KELLER SPRINGS LOFTS

LOFT APARTMENTS IN ADDISON, TEXAS

To: Jordan & Skala Engineers, Inc. RFI #: 16
14240 Midway Road, Suite 350 Date: 12/28/2011
Dallas, TX 75244 Job: EB-02 Keller Springs Lofts
Ph: 469/385-1616 Fax: 469/385-1615 Phone: 877-777-5115

LOFT APARTMENTS IN ADDISON, TEXAS

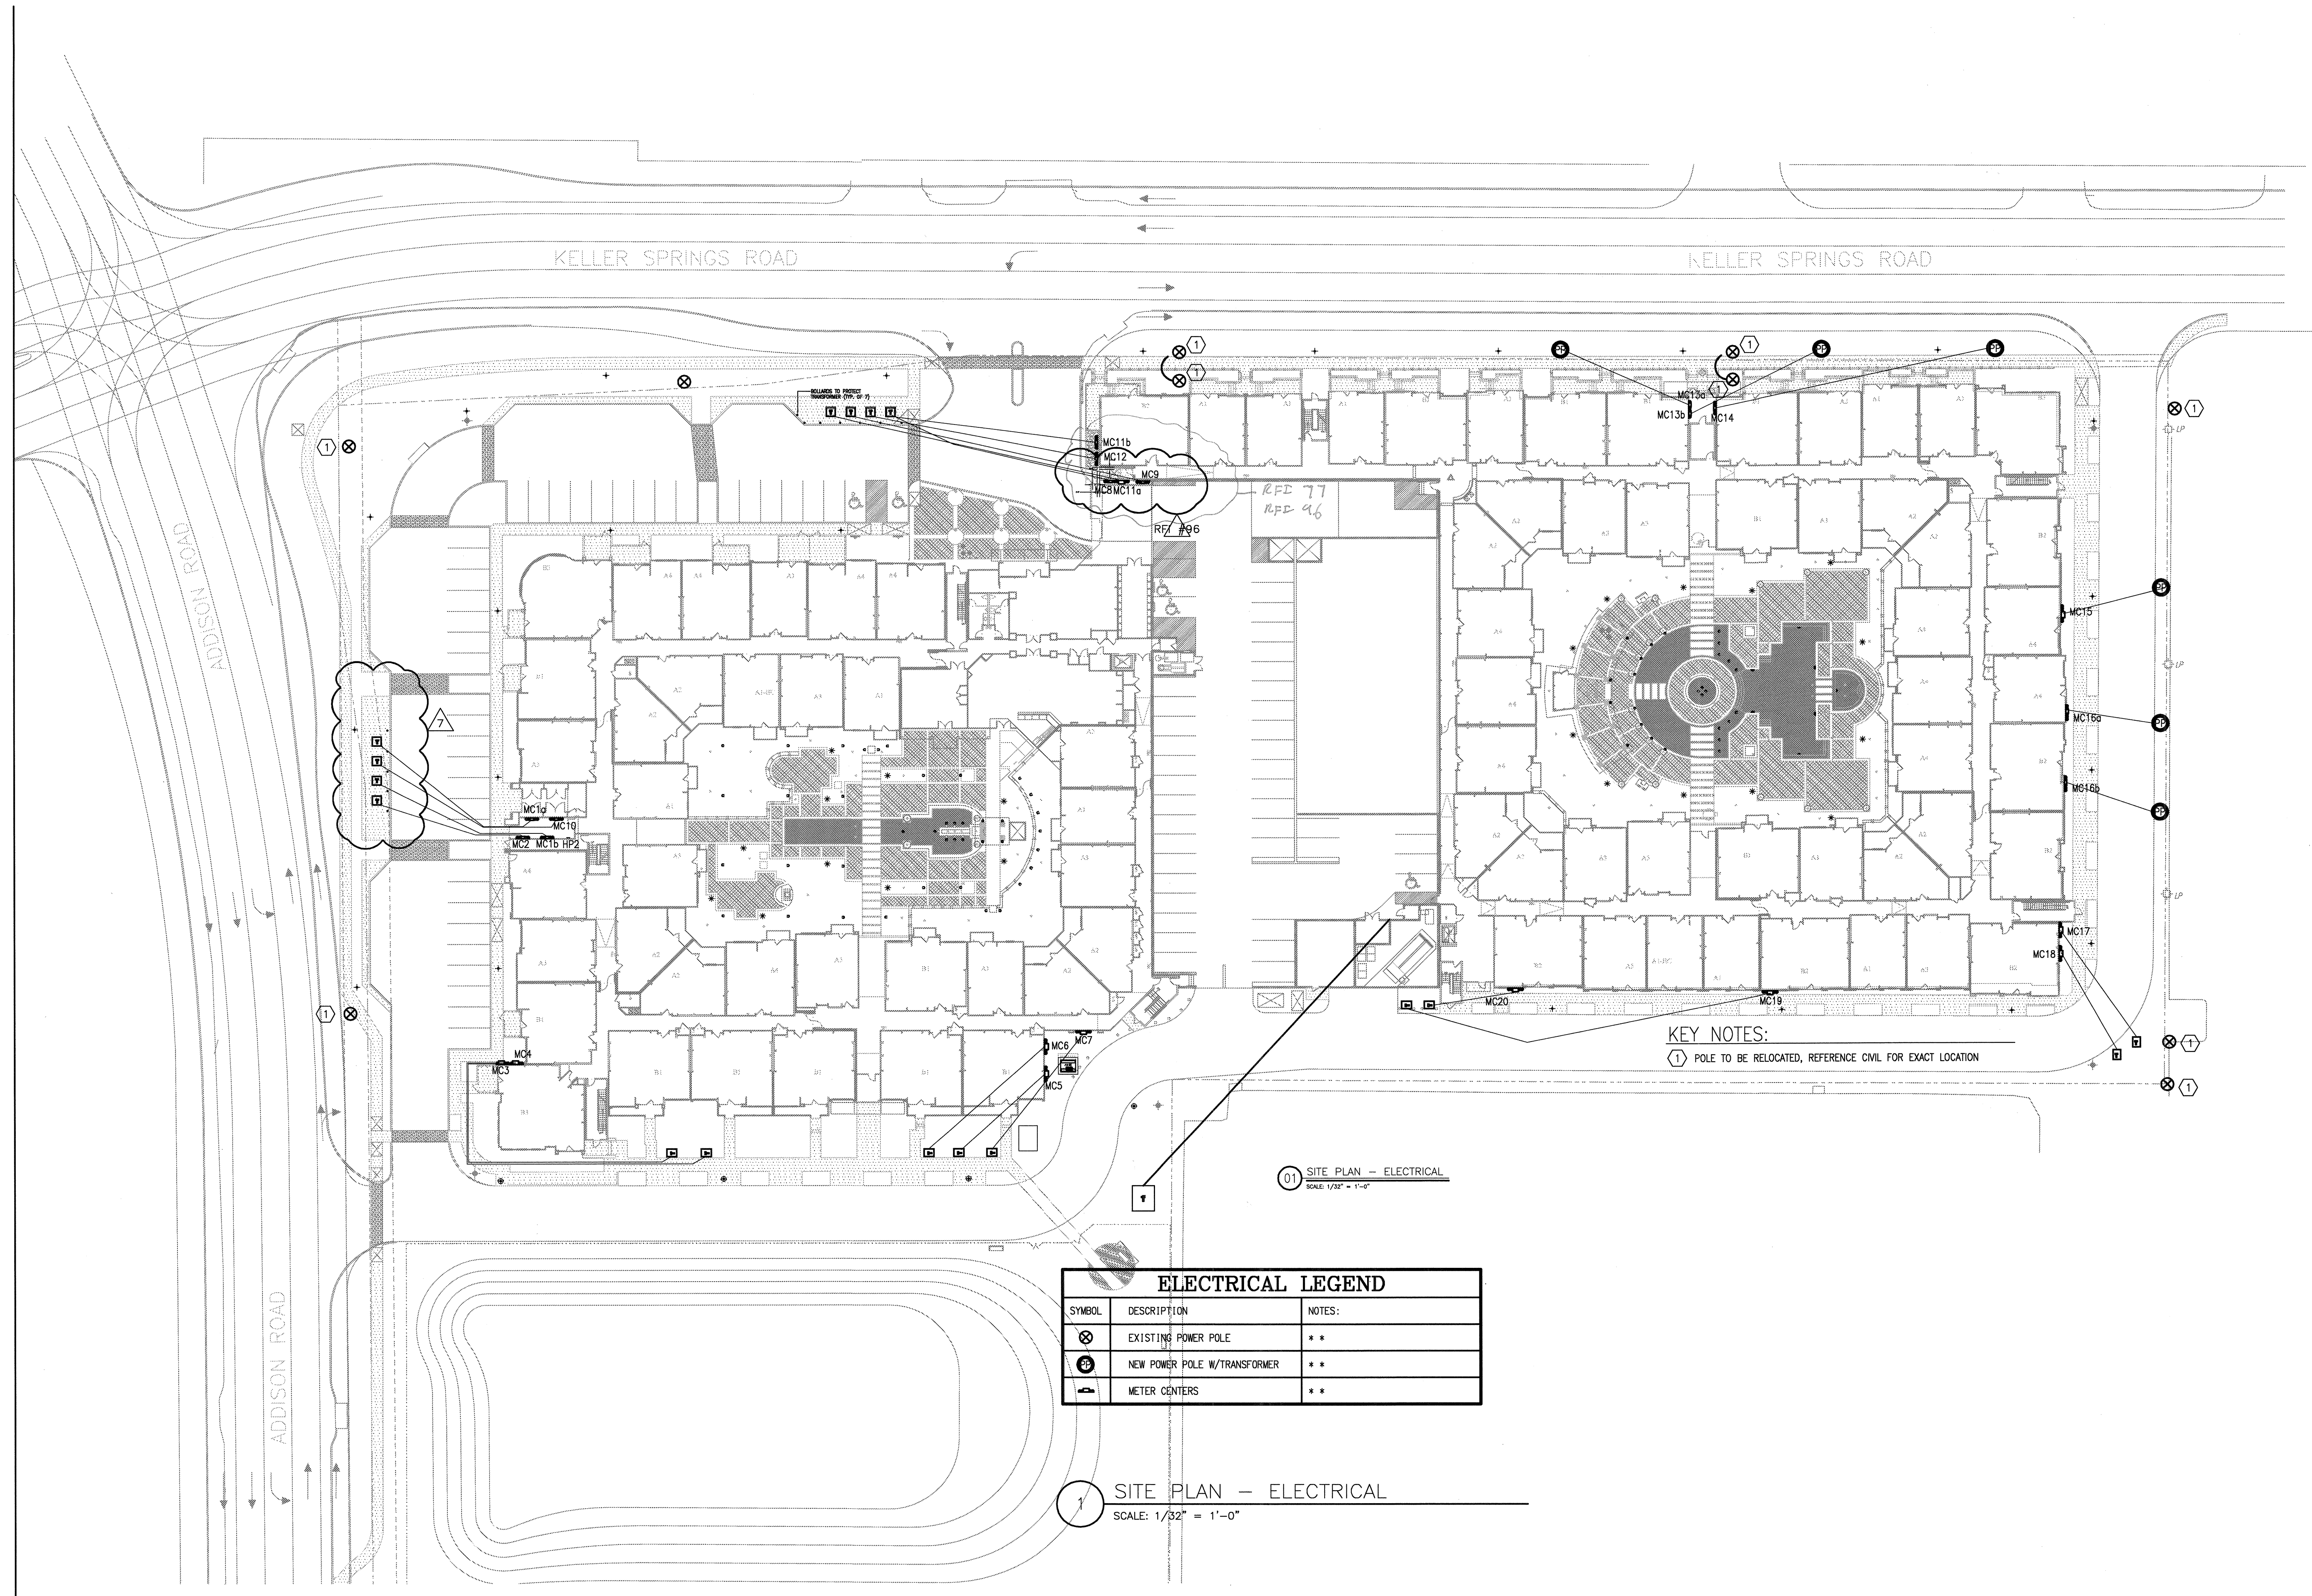
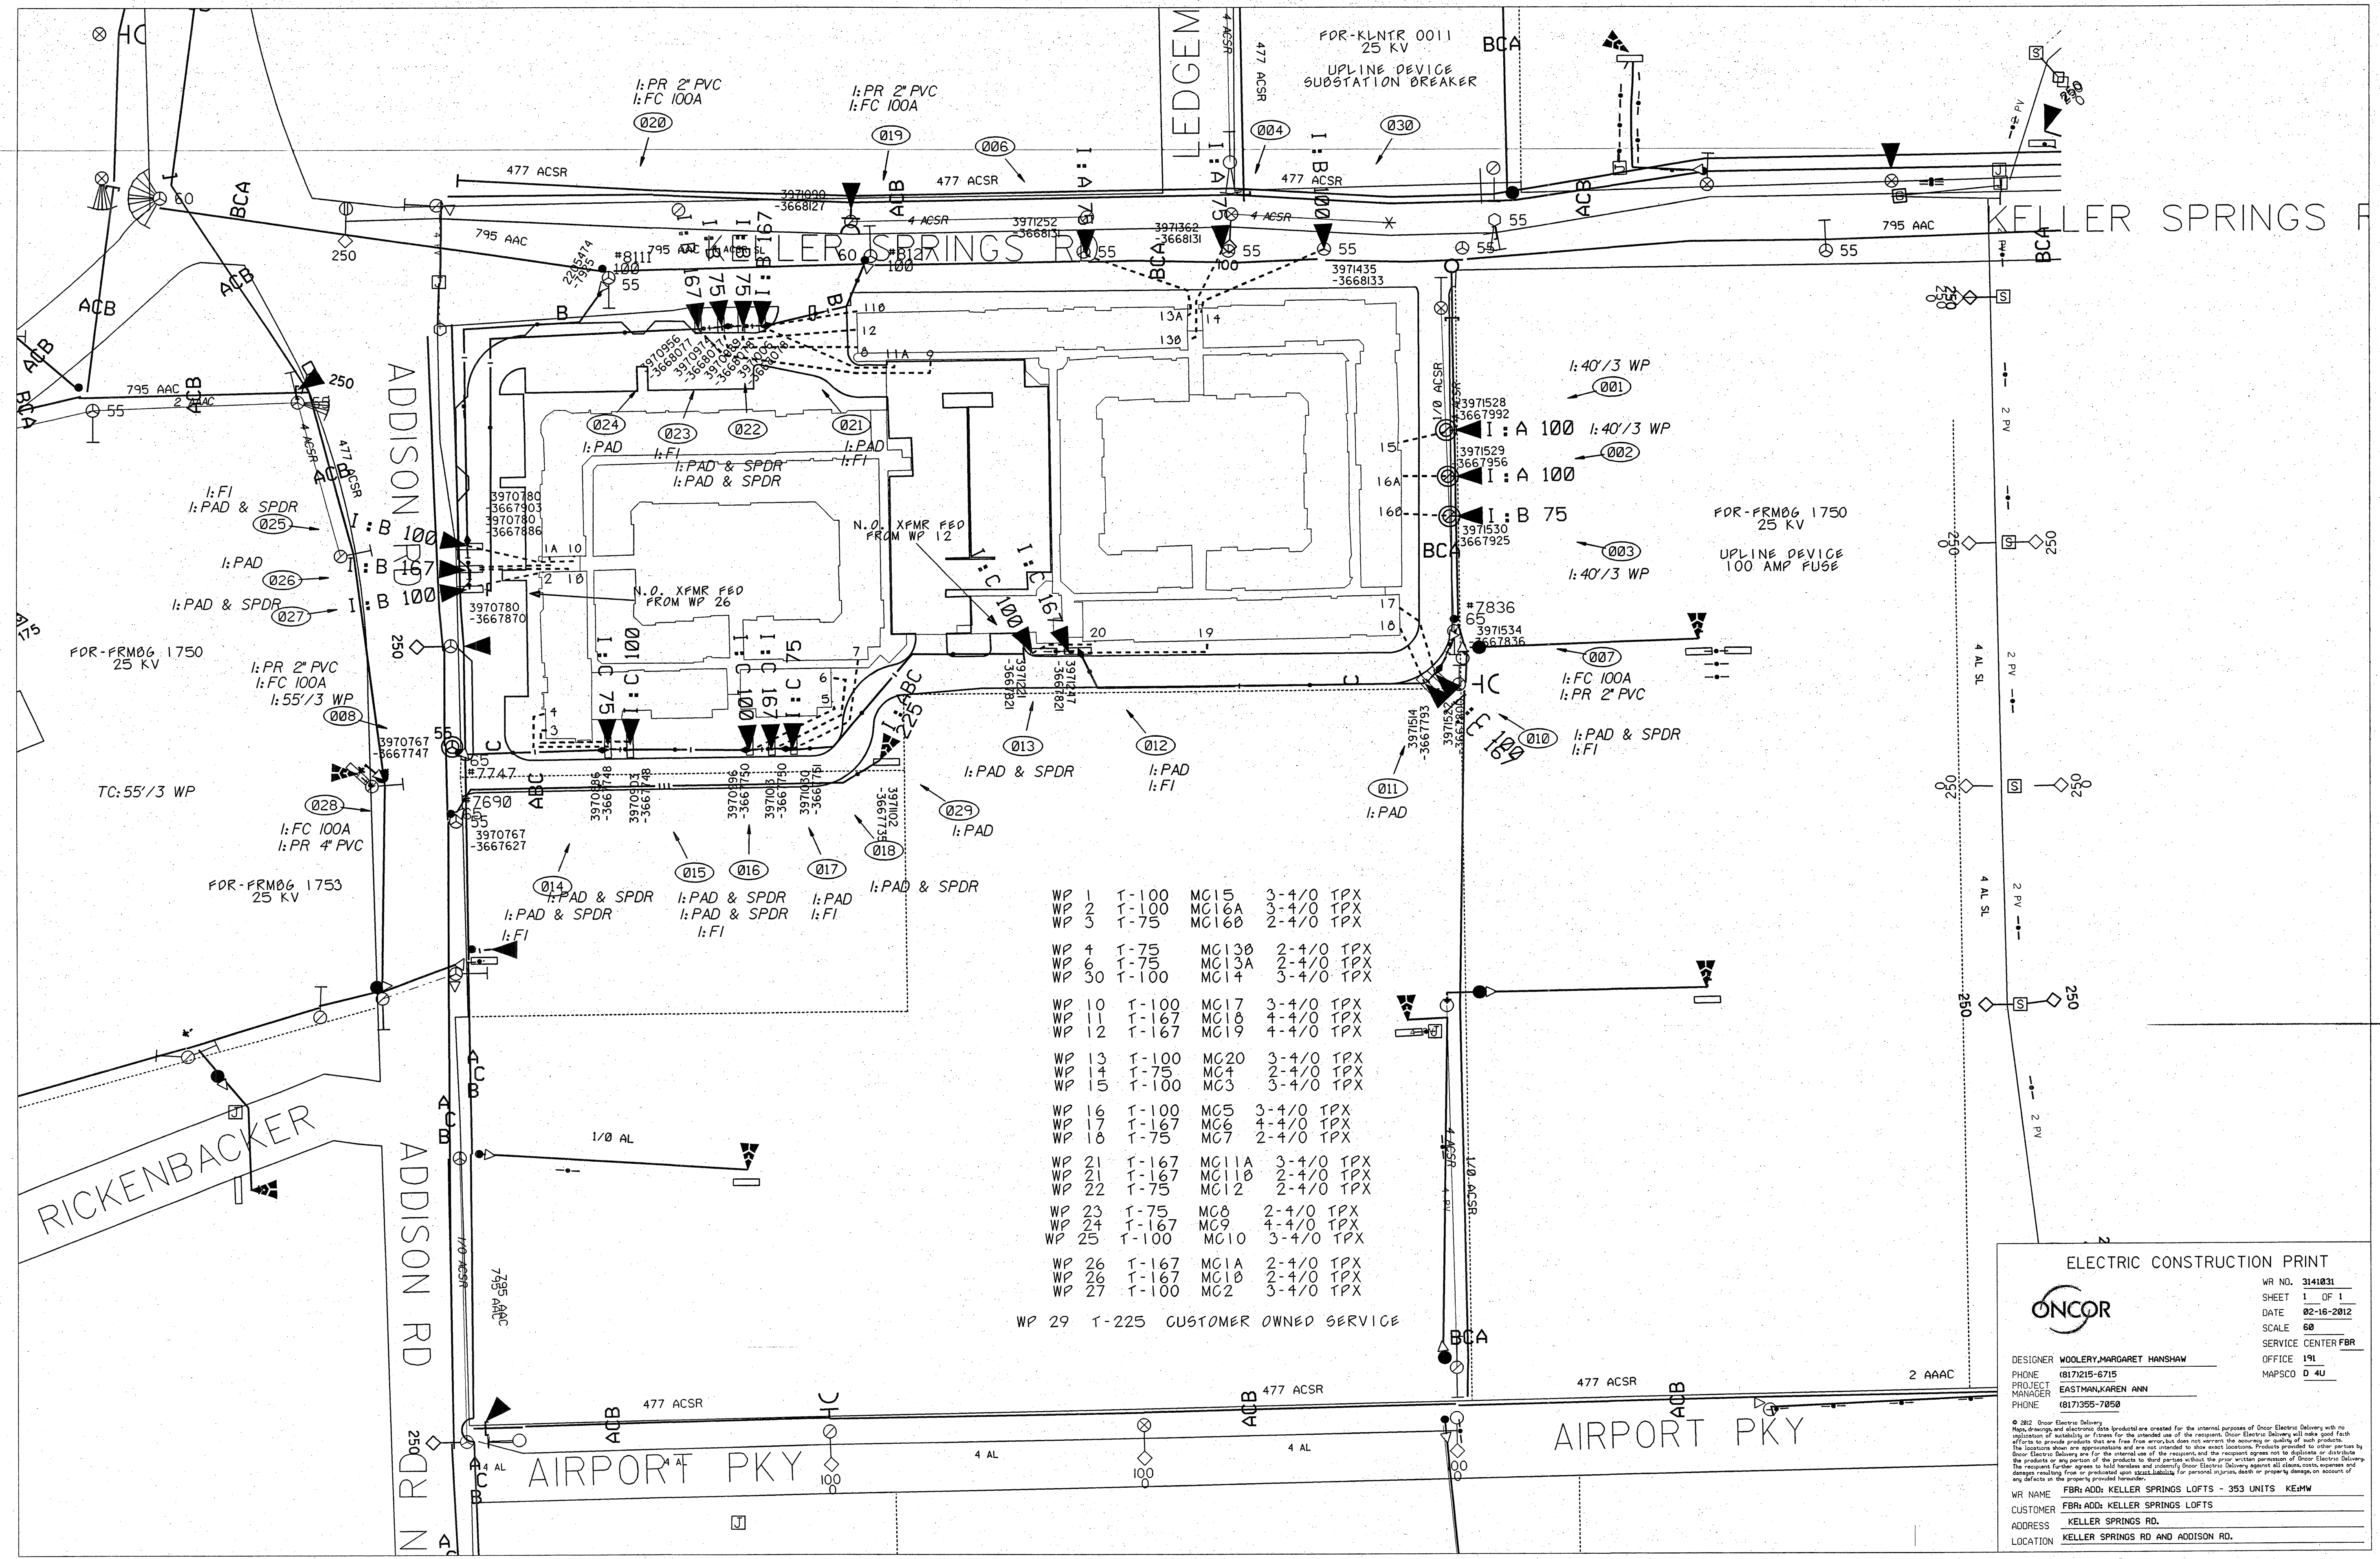
Request:
 Some of the meter centers have changed location and numbers. 3.1C in Architectural and E-3.1C have different meter center numbers than the final E-10.1 and oncor final drawing. Also, E-10.1 and Oncor show two meter centers inside the garage. This must be a mistake. The meter centers should be mounted to the exterior of the building as shown on 3.1C and E-3.1C. I think we may want to have the meter center numbers match the Oncor plans and change from 3.1C and E-3.1C. These conflicts are very confusing and need to be corrected so we get them in the right place. Please see attachments and advise.

Request:
 Please see the attached Oncor Construction Print. The following Meter Center locations do not match up with Oncor's layout. E3.1A - MC1B and MC2 are reversed from Oncor plan. These meter centers are also in the wrong location on E10.1. E3.1C - MC3, MC1A, MC1B and MC12 are different from Oncor plan. MC9 is OK. E10.1 also needs to match up with the Oncor plan. Please revise plans to match the Oncor layout.
